Form 3160-5
(June 2019)UNITED STATES
DEPARTMENT OF THE INTERIOR
BUREAU OF LAND MANAGEMENTFORM APPROVED OMB
No. 1004-0137 Expires:
December 31, 2024**SUNDRY NOTICES AND REPORTS ON WELLS**
***Do not use this form for proposals to drill or to re-enter an
abandoned well. Use Form 3160-3 (APD) for such proposals.***5. Lease Serial No. **NMLC 062486**

Operator: Acacia Operating Co., LLC
Well Name Drickey Queen Sand Unit #804
API # 30-005-01009
Location: Sec 9, T14S, R31E

**Drickey Queen Sand Unit 804
30-005-01009
Trigg Oil Co.
January 22, 2025
Conditions of Approval**

Well Bore Diagram Worksheet

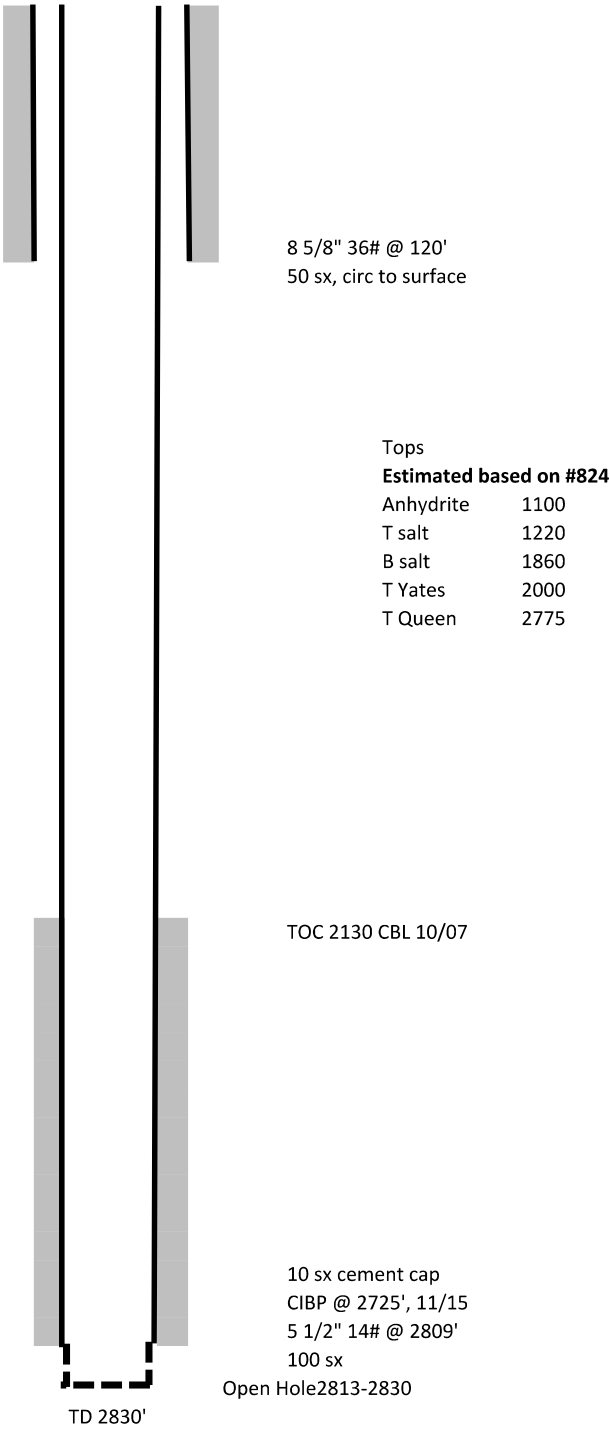
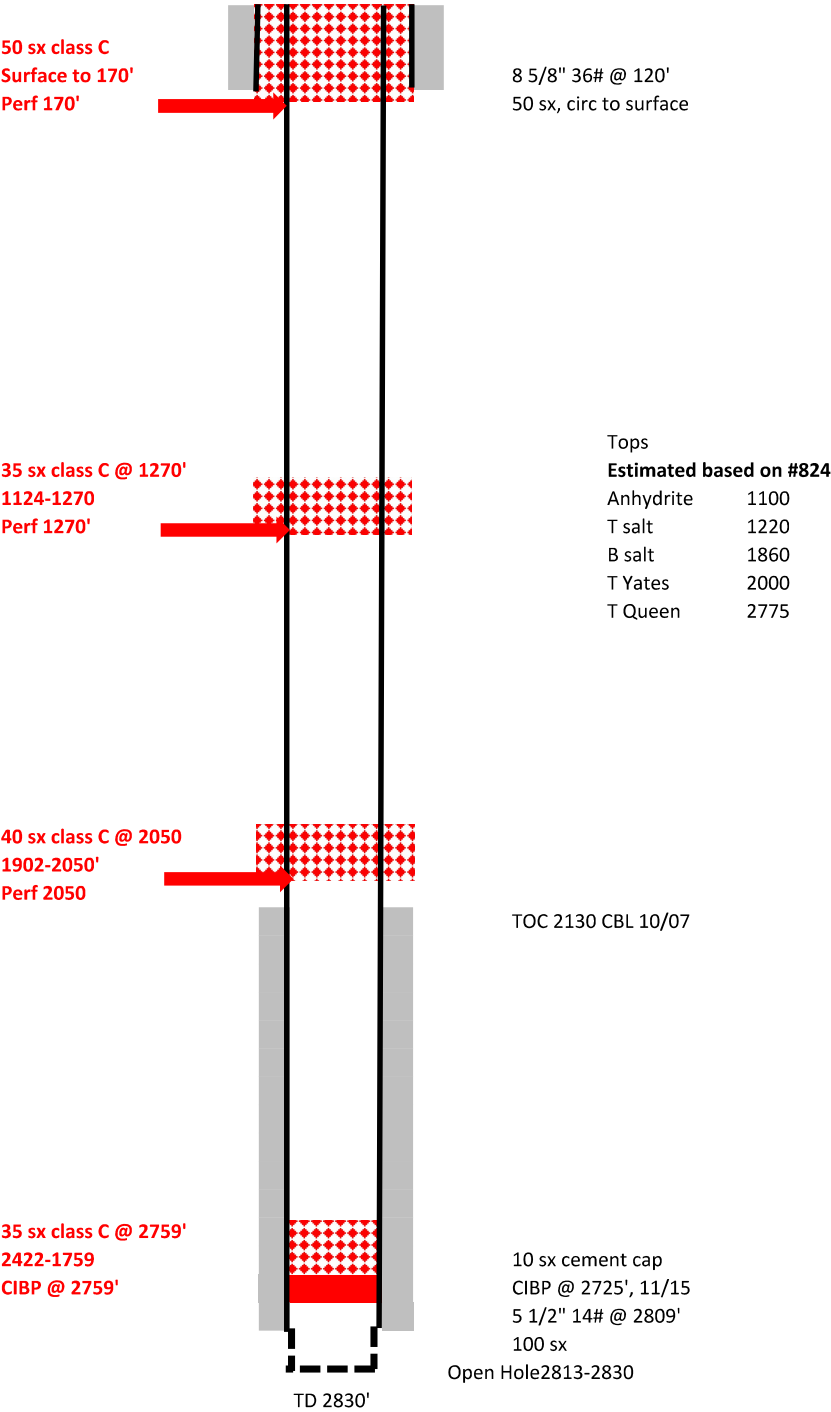
- 1. Operator shall place CIBP at 2,759' and place a minimum of 25 sx of Class C cement on top. WOC and TAG.**
- 2. Operator shall perf at 2,050' and squeeze cement class C cement to 1,844' to seal the Yates and bottom of the Salt. WOC and TAG.**
- 3. Operator shall perf at 1,270' and squeeze cement class C cement to 1,062' to seal the top of the Salt and the Rustler. WOC and TAG.**
- 4. Operator shall perf at 180' and squeeze cement class C cement to surface to seal the 13-3/8" casing shoe.**
- 5. Dry hole marker must be below ground.**
- 6. Surface reclamation will need to be completed once the well bore has been plugged. Please contact rflores@blm.gov for additional information.**
- 7. See Attached for general plugging stipulations.**
